PLANNING APPLICATION PLN-19-0192

TANNERY ROAD, LONGFORD

Re: New Residence, Tannery Road, Longford. PLN-19-0192

Additional Information Required for Planning Application PLN-19-0192- Dwelling, access & adhesion of 3 titles (Flood Prone Area, vary setbacks, within Attenuation Distance to Abattoir) at Tannery Road, Longford

1 SITE PLAN
1:500

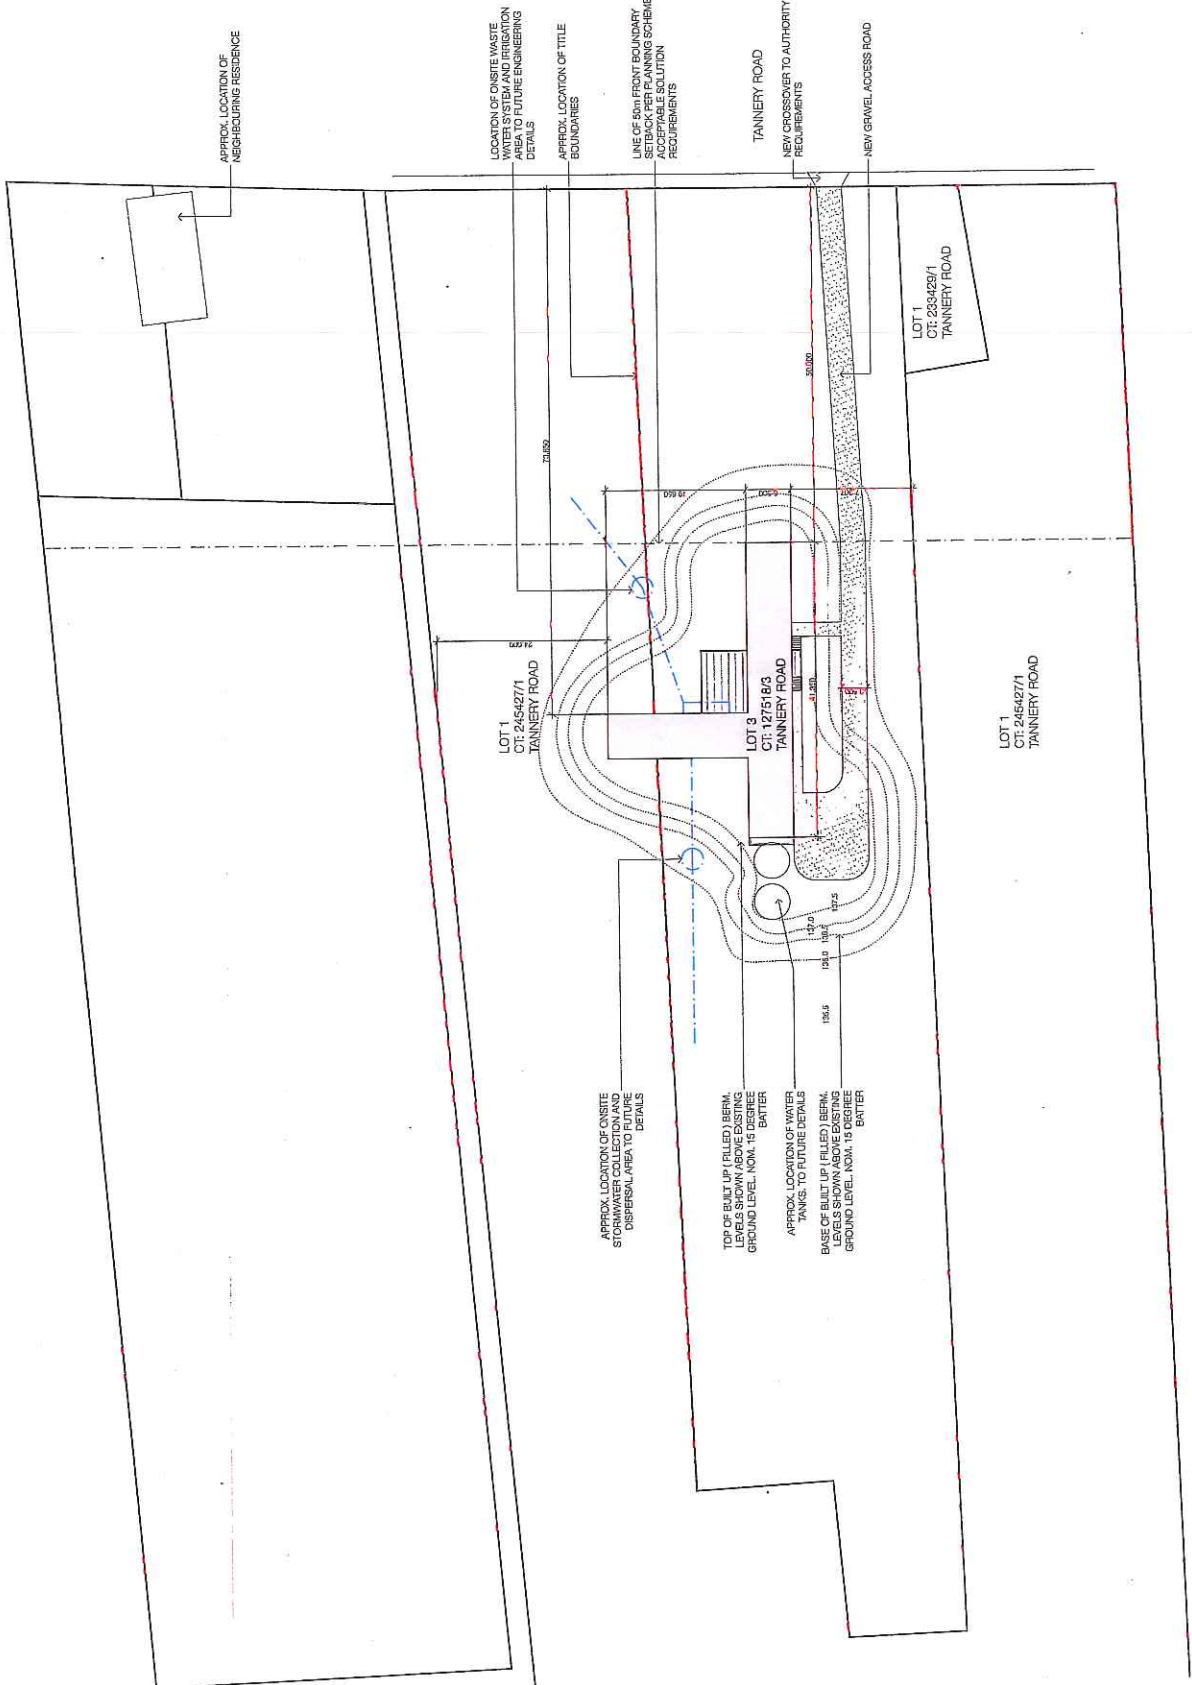
- **Revised site Plan**
Please provide a revised site plan that correctly depicts the location of the neighbouring buildings.

2. Within the application, and specifically the MJ Architecture drawing package, there are various indications that a raised berm of approximately 1.5m in height (estimated from contours on drawing D01.02) is to be developed to mitigate the potential impacts from flooding, for which the following points are raised (generally as a result of my experience in the industrial and energy construction industries):

7. In drawing D01.02 it is noted that an onsite wastewater system and irrigation area are proposed in the areas closest to our property which is unacceptable. It is expected that the proponent reconsider this or, if approved, be directed to implement such measures that minimise the potential for runoff into our property as a part of normal operation, as well as situations where the water table rises as part of non-flooding and flooding events.

An updated site plan is attached. The location of the neighbouring building has been approximated as best as possible from ListMap aerial photos

ELEVATIONS

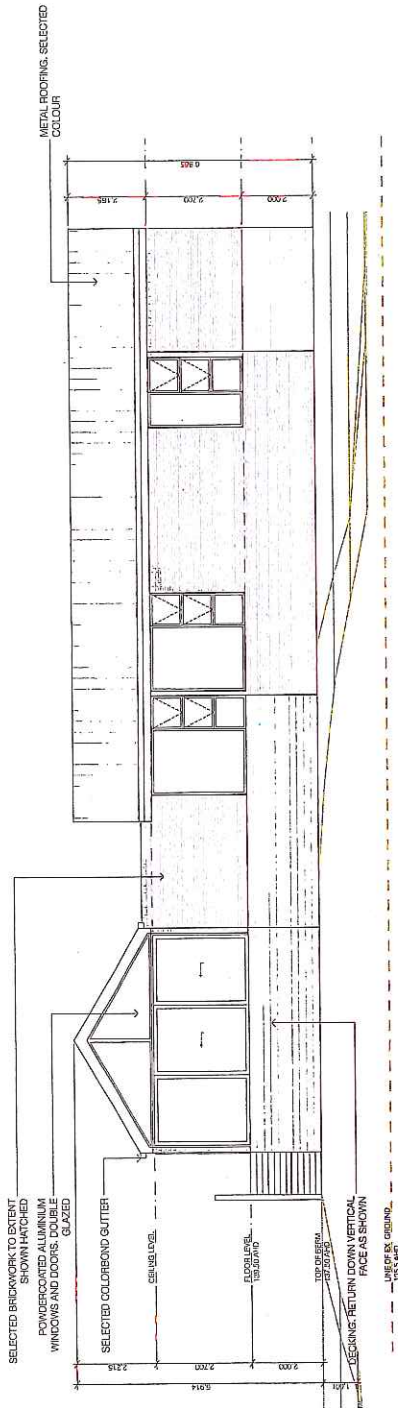
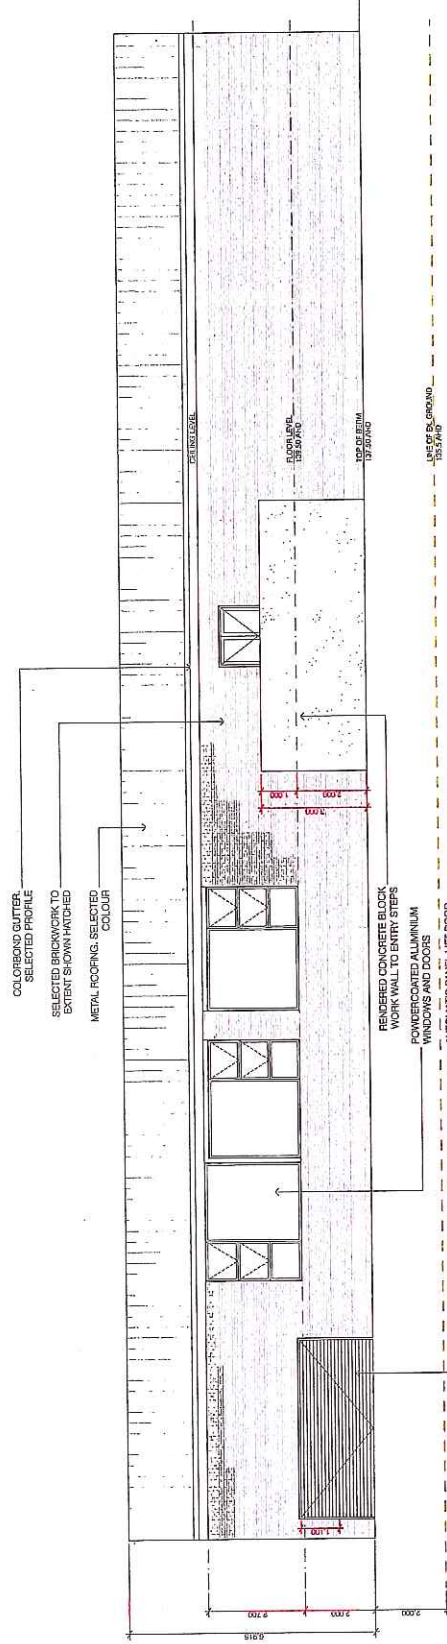
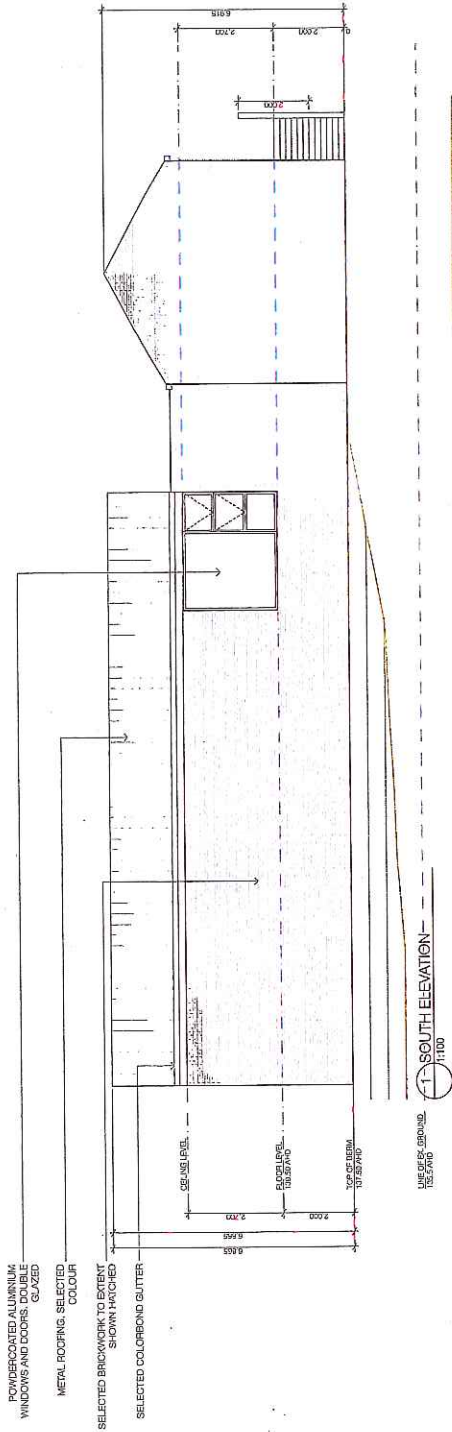
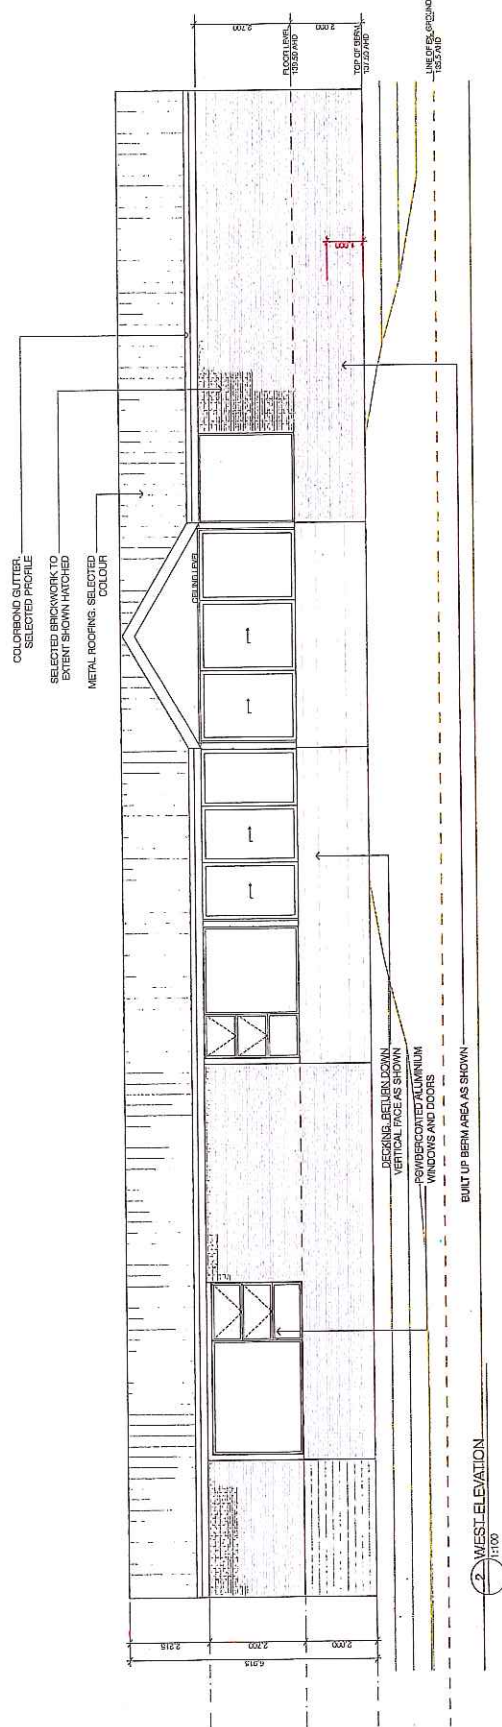
- Updated elevations to show ground levels to match site survey or flood report levels. I note that ground elevations at the site are likely to be between 135-136 AHD based on Government Data (see below). This is required to accurately show the height of the floor level, relative to natural ground level.
